**3GPP TSG RAN WG1 Meeting #9  
Dresden, Germany, 30 Nov - 3 Dec 1999**

**Document R1-99J28**

| <b>25.222</b>   | <b>CR 008rev1</b>  | Current Version: <b>3.0.0</b>   |

**Subject:**      TFCI coding in TDD

**Figure 4-7: Encoder structure for (32,10) sub-code of second order Reed-Muller code**

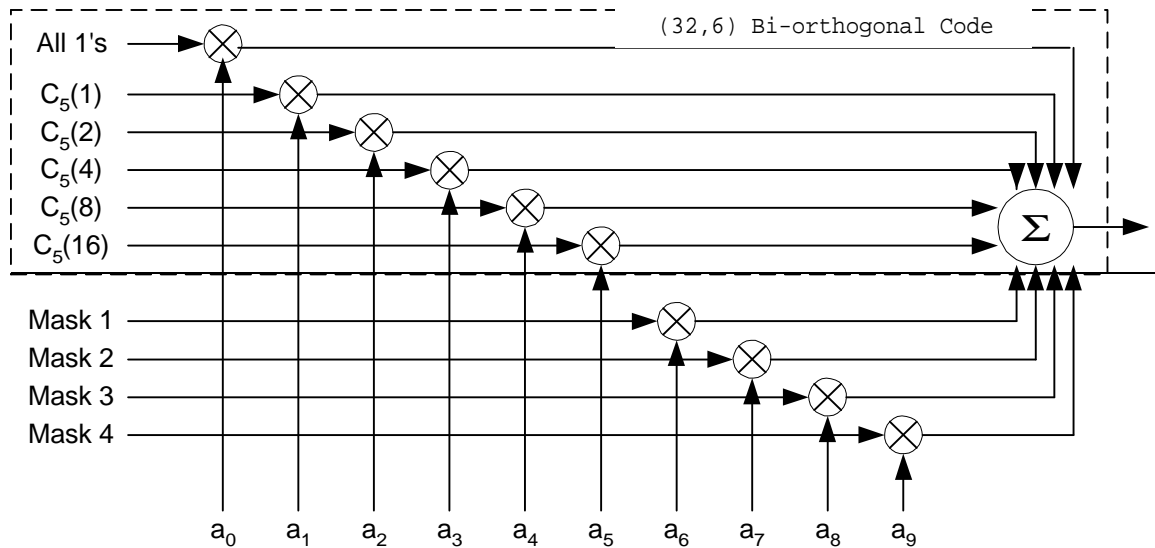
**Reason for change:**      Description of TFCI coding for normal and short length cases is quite different and does not specify coding process completely. Also dependency on OVFS sequences defined externally which should be removed.  
 Remove narrative text in 4.3.1  
 Change 4.3.1.1 to more specification-like form  
 Add 4.3.1.2.1, 4.3.1.2.2 section headings to make clearer different rules

For TFCI information bits  $a_0, a_1, a_2, a_3, a_4, a_5, a_6, a_7, a_8, a_9$  ( $a_0$  is LSB and  $a_9$  is MSB), the encoder structure is as follows in figure 4-7. output code word bits  $b_i$  are given by:

$$b_i = \sum_{n=0}^9 (a_n \times M_{i,n}) \text{ mod } 2$$

where  $i=0...31$ .
